# PlanGrid Task Report - Apr 17, 2025

Prepared by Ian Fuller

## #289 [CNTL 512] [NEW] SEC Line voltage cover.

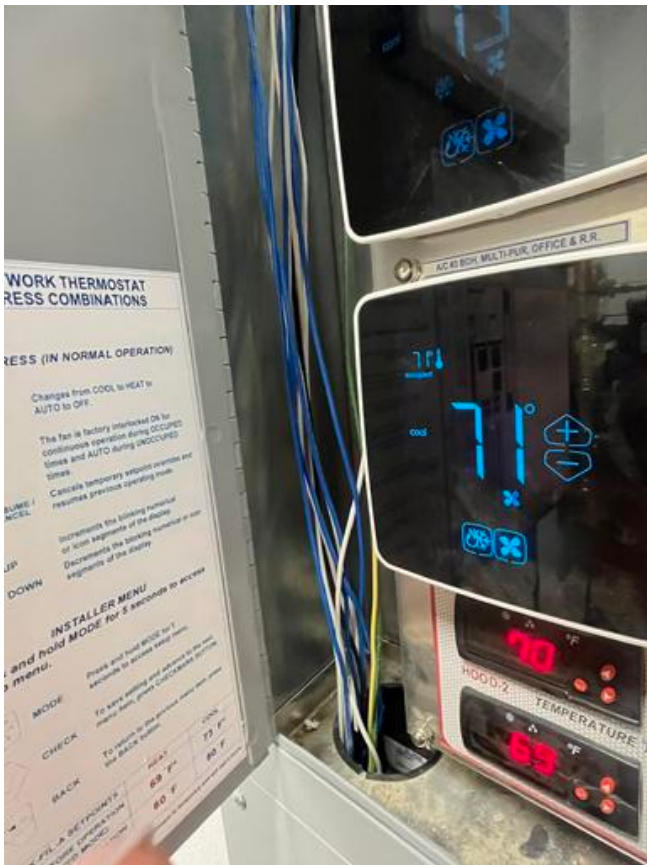
Line voltage cover in SEC low voltage panel is missing and needs to be installed (EC).
